Permit No... 87-32

TOWN OF ACTON

APPLICATION FOR PERMIT TO CONSTRUCT WITHIN A PUBLIC WAY

SUBJECT: PERMIT TO CONSTRUCT WITHIN A PUBLIC WAY # 87-32

**TOWN OF ACTON
TYPICAL DRIVEWAY 8
TRENCH DETAIL
FEB. 1969
NO SCALE**

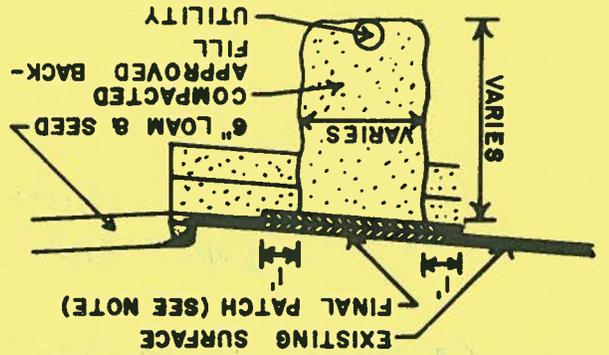
*INSPECTION 4-20-88 DEP
Shoulders O.K.
Temporary Patch Not Acceptable - Settling
Edges Not Cut.
Overlay will not be acceptable.*

The patch you installed over the water service connection does not constitute a permanent patch as required by section II-D-3 of the Town of Acton Specifications for Regulating Construction Within Public Ways. The temporary patch must be dug out, the edges cut back 1' along the line of construction, and a new patch installed. The new patch must be a minimum of 3" of bituminous concrete, and the edges must be sealed. A "skim-coat" over the existing patch will not constitute a proper repair.

*INSPECTION 6-22-88 DR-JR - patch completed - looks good
smooth
joints sealed*
